PROJECT PLUTO DATA CENTRE – 132 MCCREDIE ROAD, GUILDFORD WEST

Submissions Report –
SSD69223466

Prepared for
GOODMAN PROPERTY SERVICES (AUST.) PTY LTD
30 July 2025

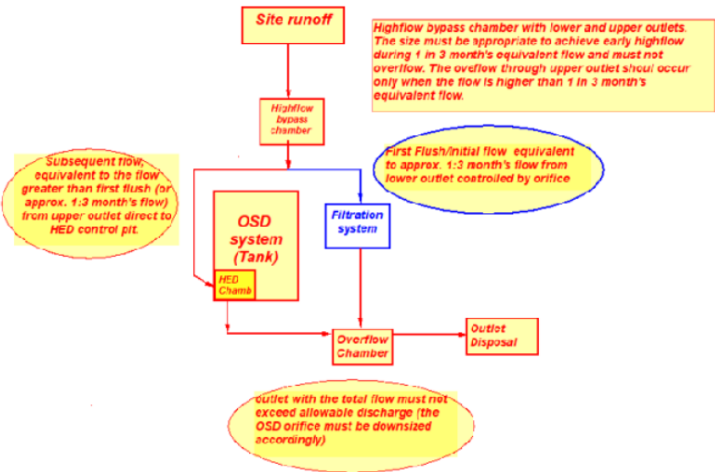
<p>As such, the façade of the development shall be reviewed to ensure the long blank concrete sheeting walls shall be redesigned to incorporate various architectural features, materials and finishing, design or potentially wall art to minimise visual impact of the proposed data centre building.</p>	<p>The treatment of the substation will be subject to further discussions with Endeavour Energy.</p> <p>Refinements are proposed to the eastern elevation of the data centre building to provide greater articulation and visual interest when viewed from Guildford West Sportsground. The proposed refinements include the introduction of a geometric pattern articulated through the precast concrete external walls. The pattern will vary</p>

Summary of Issue Raised	Response	Supporting Document
	<p>subtly across the façade and provides additional texture and depth along this elevation.</p> <p>Overall, the eastern elevation will have a high-quality and contemporary appearance. The proposed refinements provide additional visual interest within the site whilst enabling the development to respond to the construction and operational requirements of the data centre.</p>	
Front building facade		
<p>As shown on the architectural plans, glass walls will be used for the proposed new office area located to the front of the new data centre building which is be minimised and is not ideal for urban heat. Accordingly, it is recommended the external front façade of the office area to be amended to incorporate various architectural features, materials and finishing and design to minimise the use of reflective glass.</p>	<p>The glazed facade will provide a contemporary and high quality appearance that will activate the northern facade of the proposed development and distinguish the office component from the proposed data halls. The glazed facade will optimise natural daylight within the office and contribute to the high level of amenity for future staff.</p> <p>Black mullions and transoms on the facade will create consistent horizontal articulation.</p> <p>The refinements now proposed include the introduction of horizontal shade screens on the office facade. The screens will be evenly distributed to provide effective solar control and improve internal comfort and will support a well-considered and functional façade design</p>
